ADDENDUM #1

PROJECT: Secure Entry Office Addition and Building/Site updates
at Manor Elementary School
for Monroe Public Schools
#20161

LIGHTING AND POWER PLAN - WEST

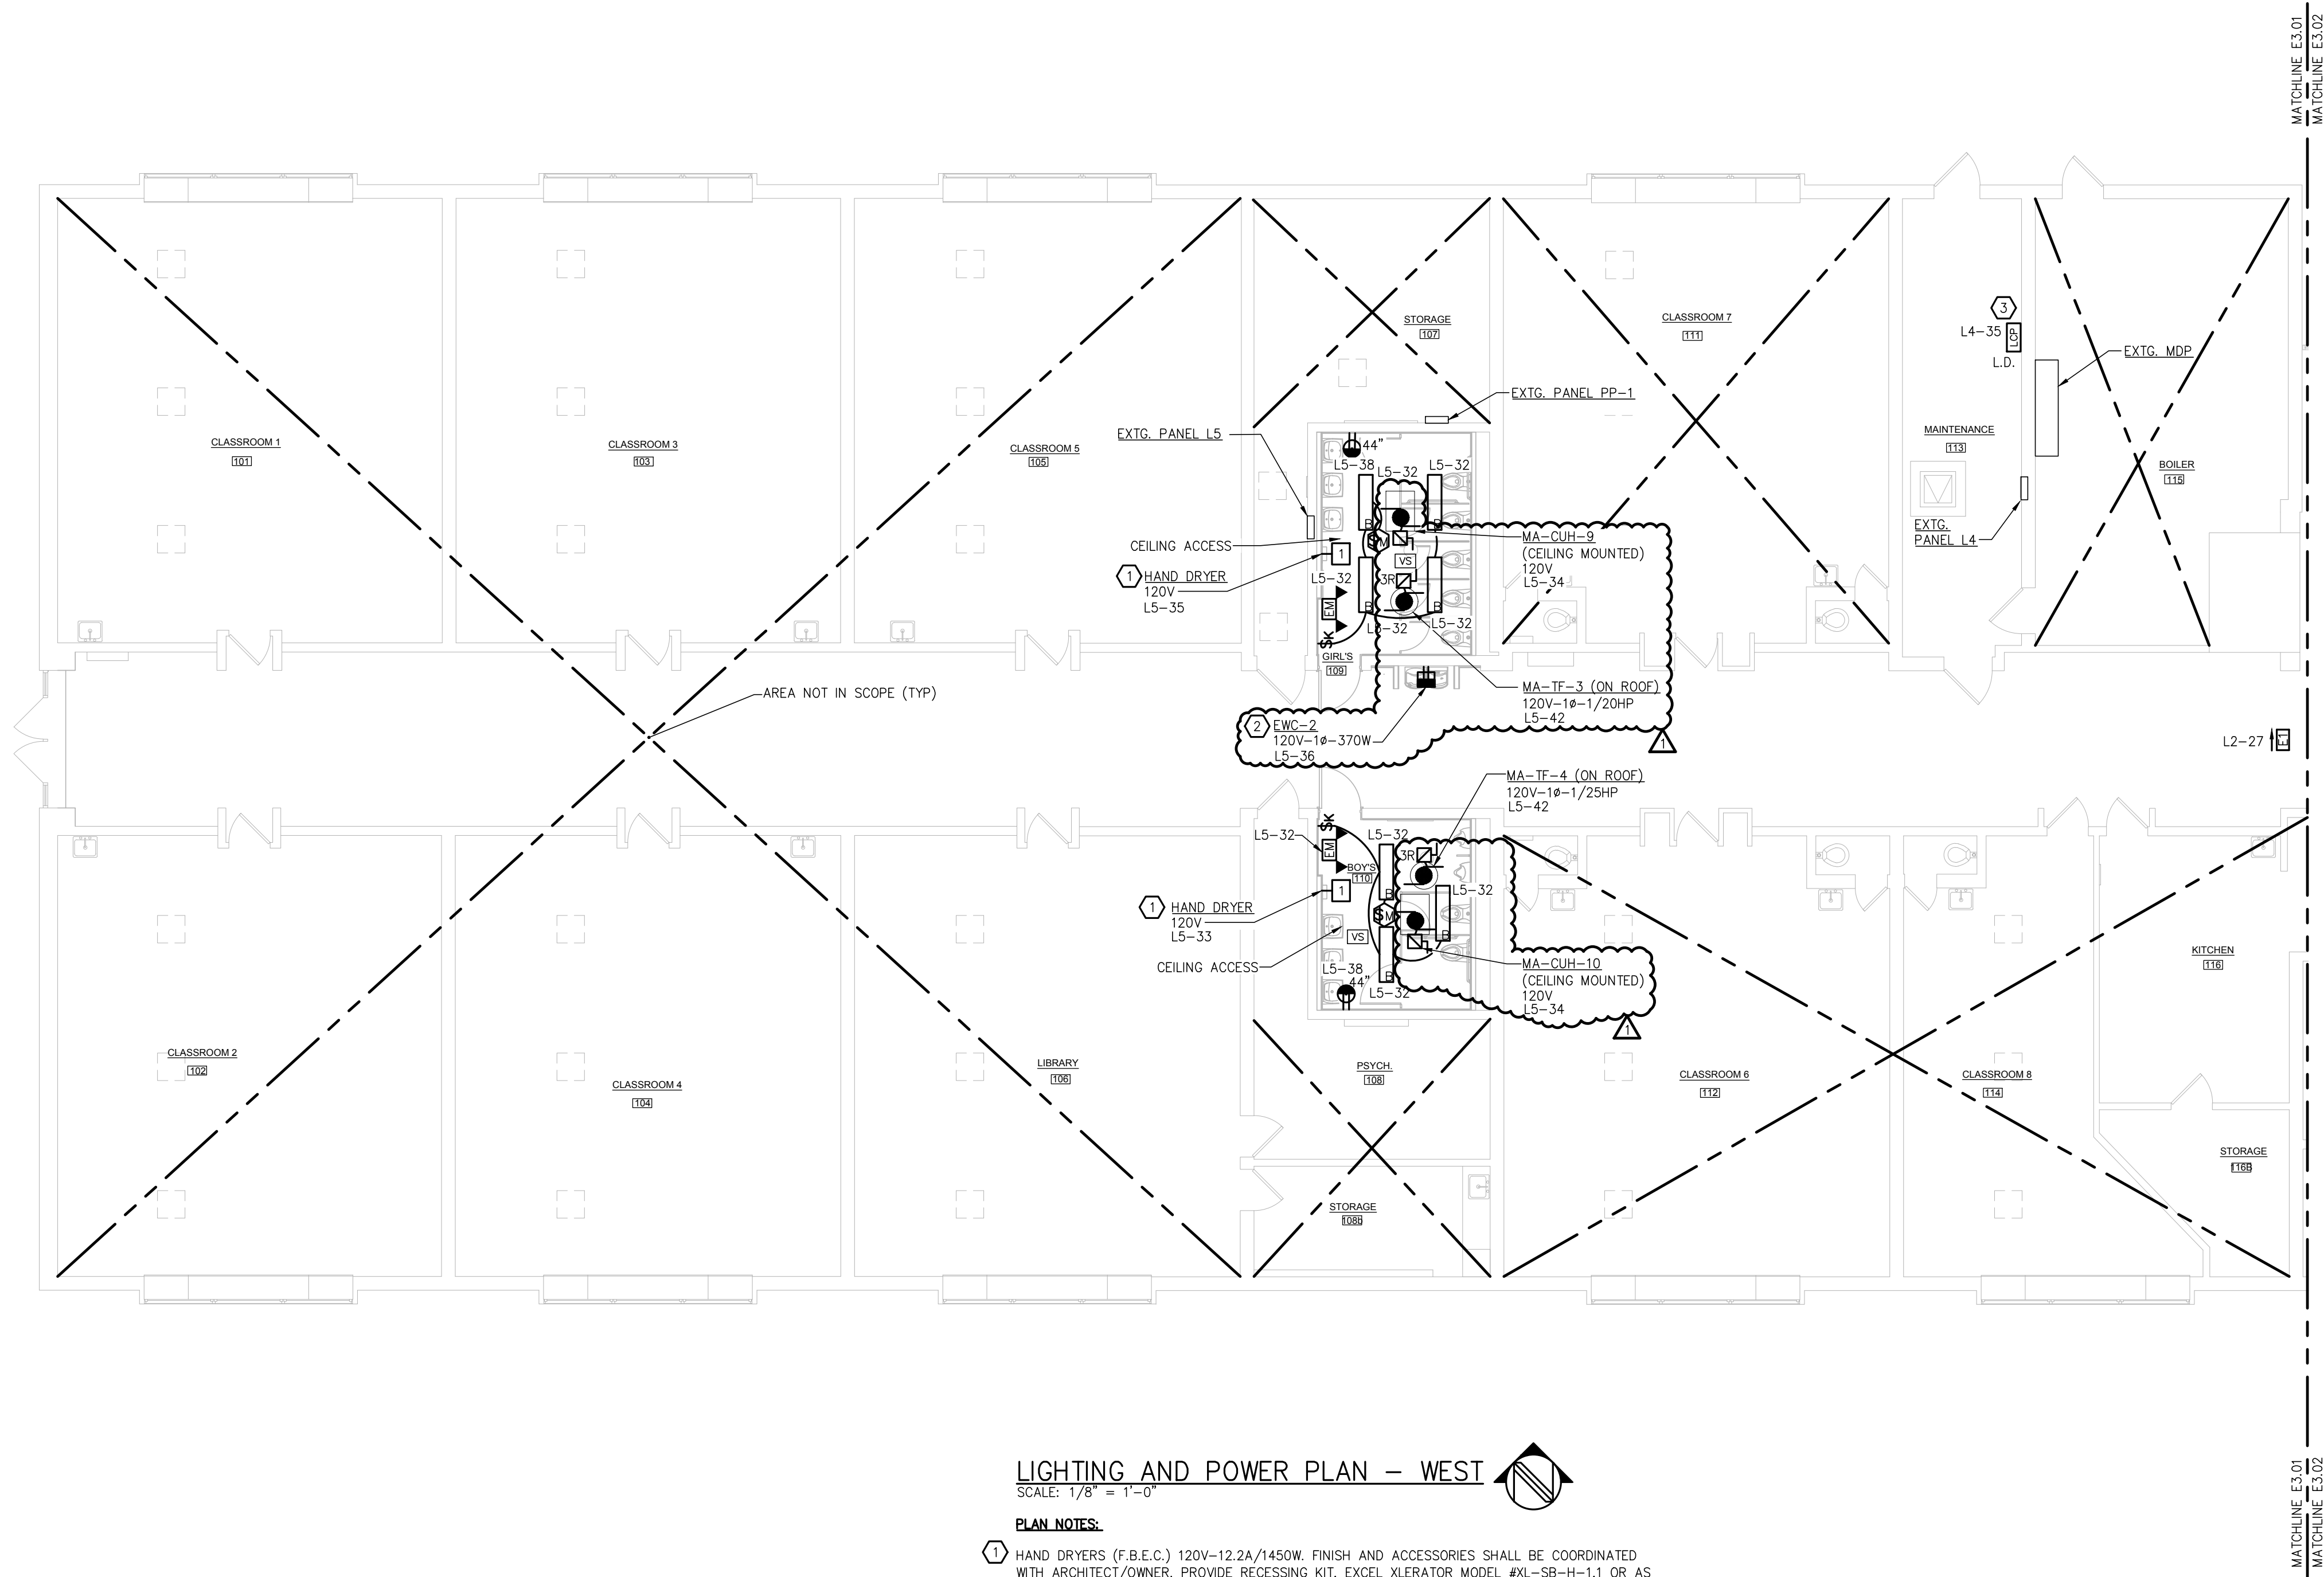
- C. Refer to drawing E3.01 LIGHTING AND POWER PLAN - WEST (Re-issued Herein)
 - 1. Revised lighting layout in Boy-110.
 - 2. Added CUH-9 and CUH-10 in Girls-109 and Boys-110.

POWER PLAN – SECURE ENTRY

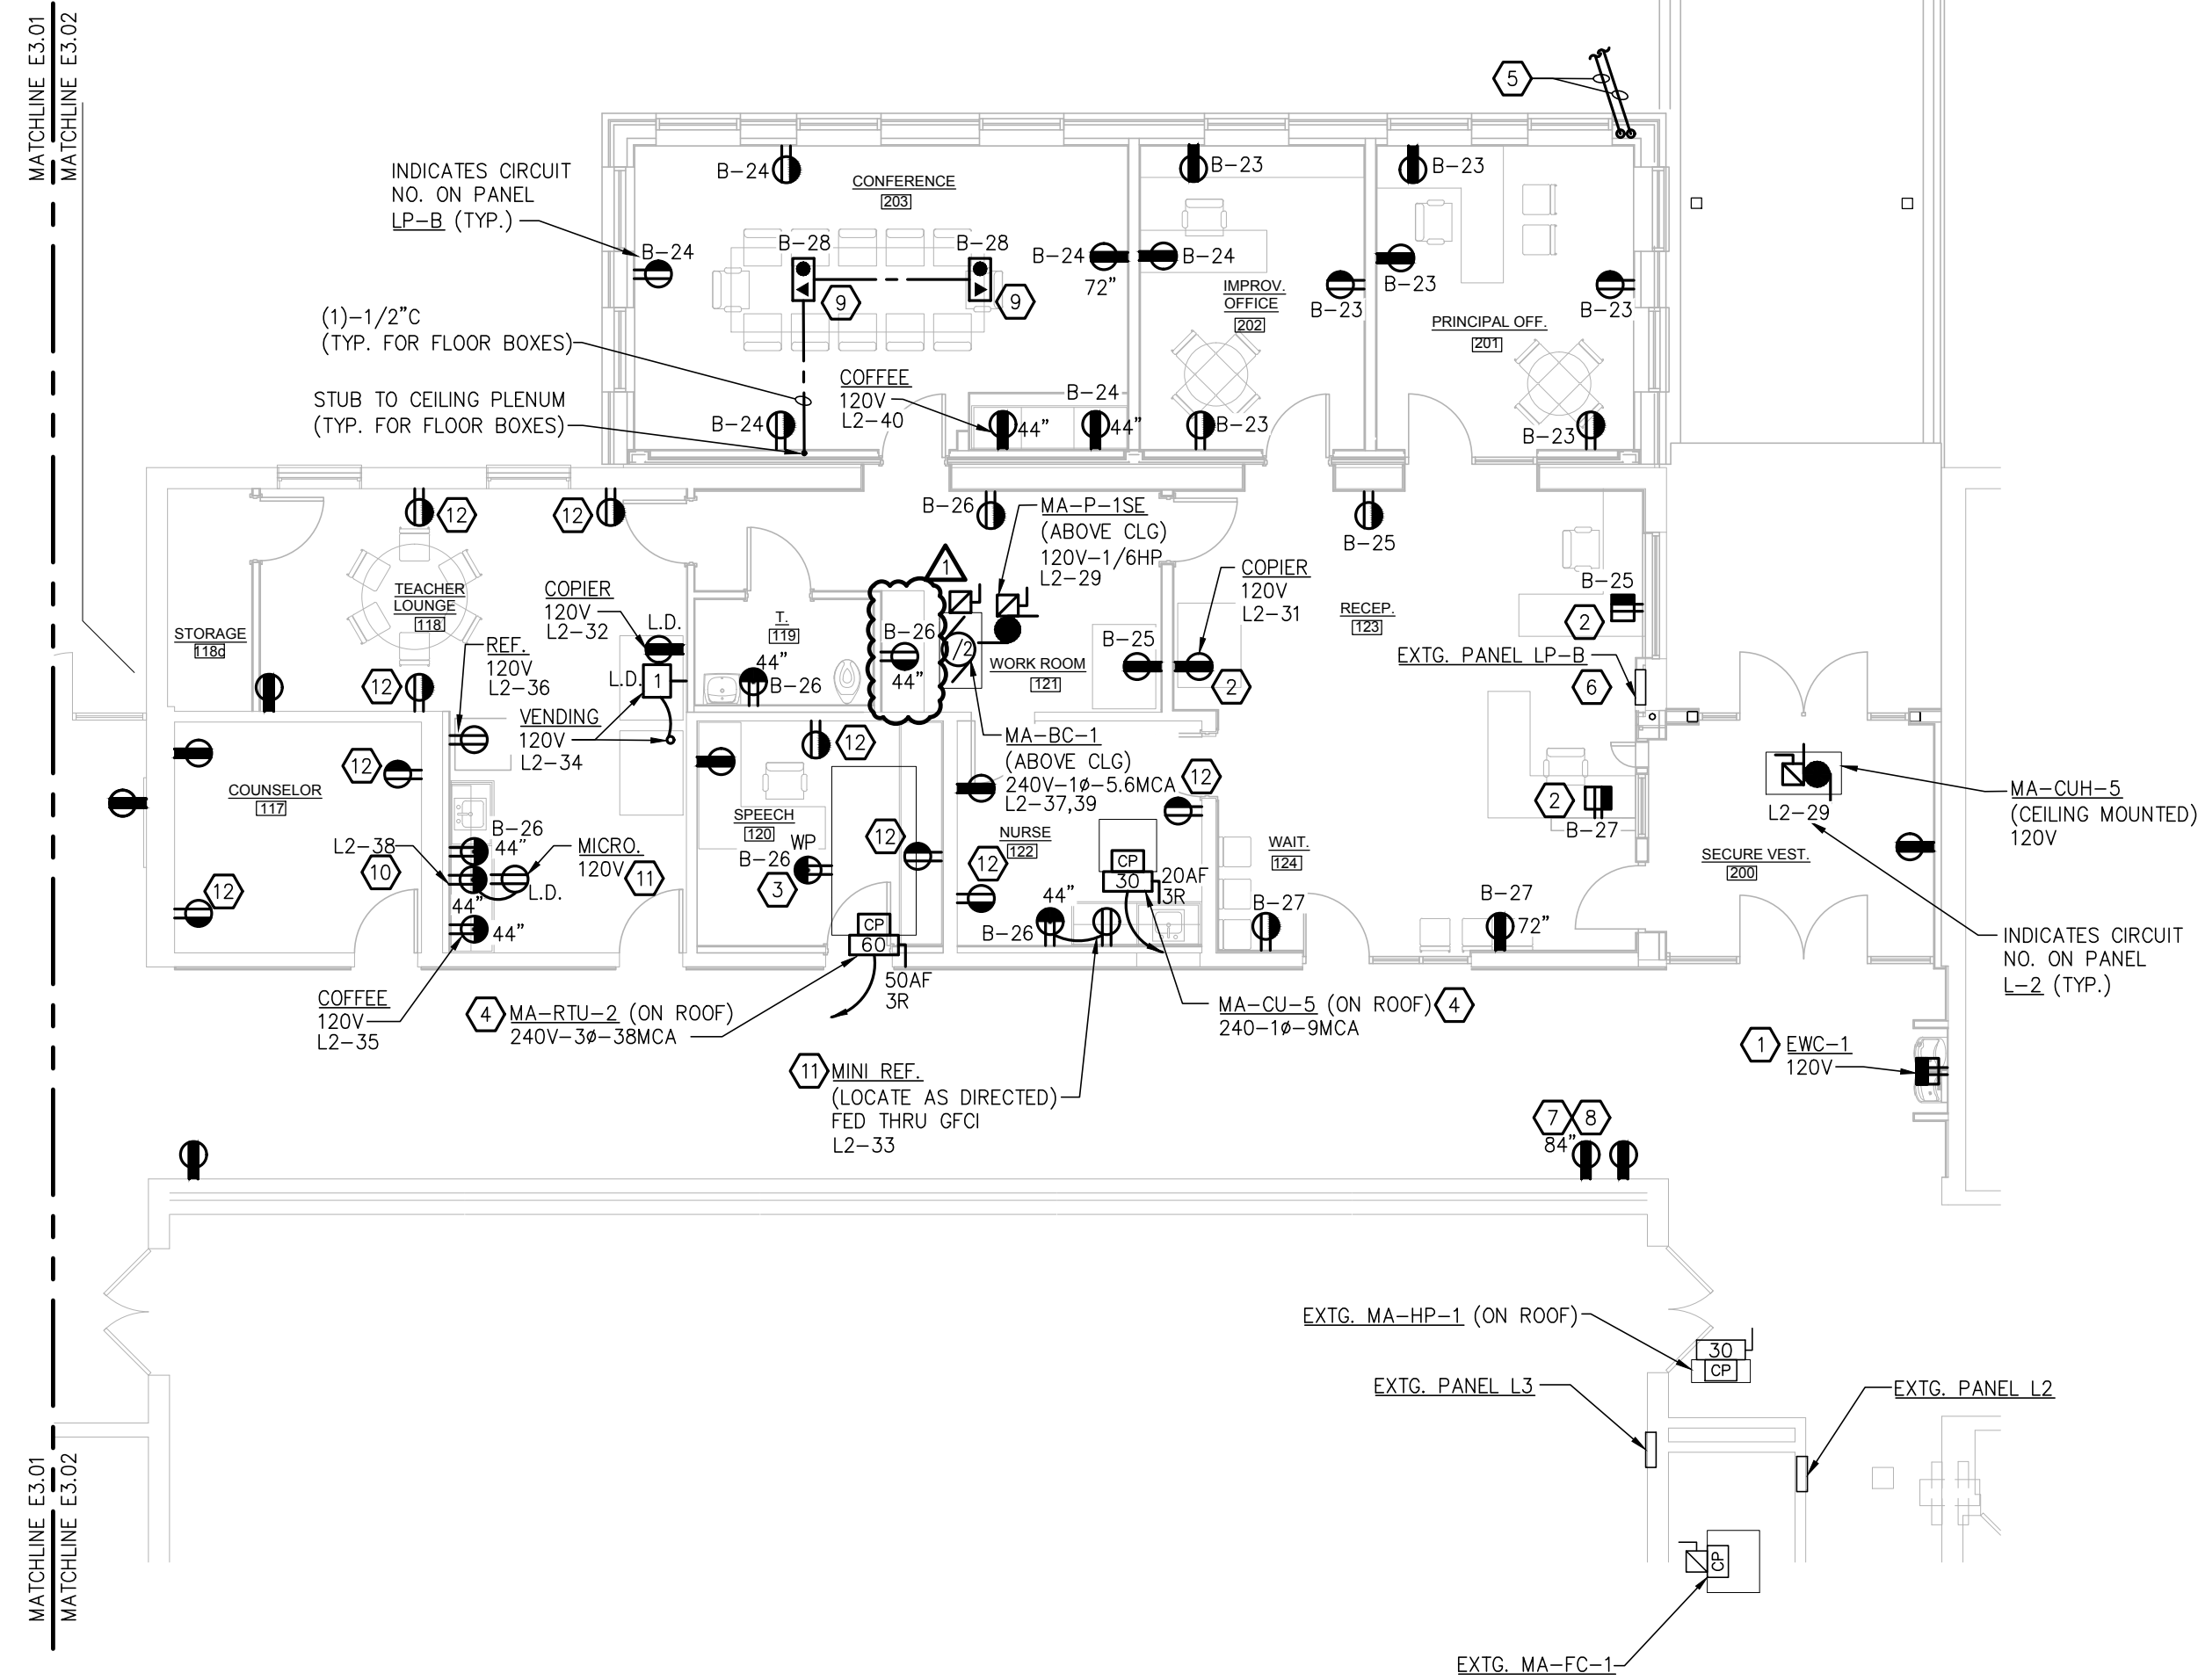
- D. Refer to drawing E3.02 LIGHTING AND POWER PLAN – SECURE ENTRY (Re-issued Herein)
 - 1. Revised receptacle location in Work Room- 121
